Village of Morton Grove  
**PLAN COMMISSION MEETING**

CASE: PC 24-06

CASE: PC 24-07

Attachment A  
Plan Review Comment Form for PC 24-06,  
Prepared by Keith White, Traffic Safety Commission Chair  
Dated September 9, 2024

Figure 1: Parking Lot Modifications

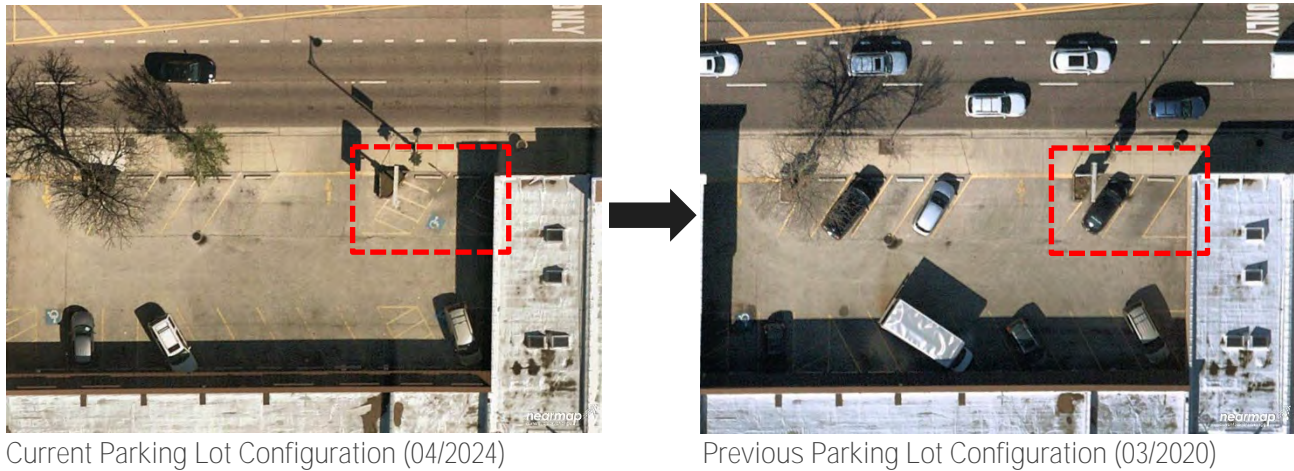
8. The applicant has not provided a plan that compares all dimensional aspects of parking spaces and circulation comply with Village requirements. The Traffic Study mentions this should be confirmed in a future effort. The representation of the number of parking spaces could vary be a few parking spaces. The Special Use Permit

process should include a requirement to confirm the number of parking spaces these parking lots can provide. This step should be completed before approving the Special Use Permit.

Furthermore, Kimley-Horn recommends restriping the one angled ADA parking space in the northeast corner of the north site parking lot into two regular angled parking spaces, as depicted in Figure 1. This would increase the parking supply in this parking lot from 15 spaces to 16 spaces while maintaining ADA compliance.
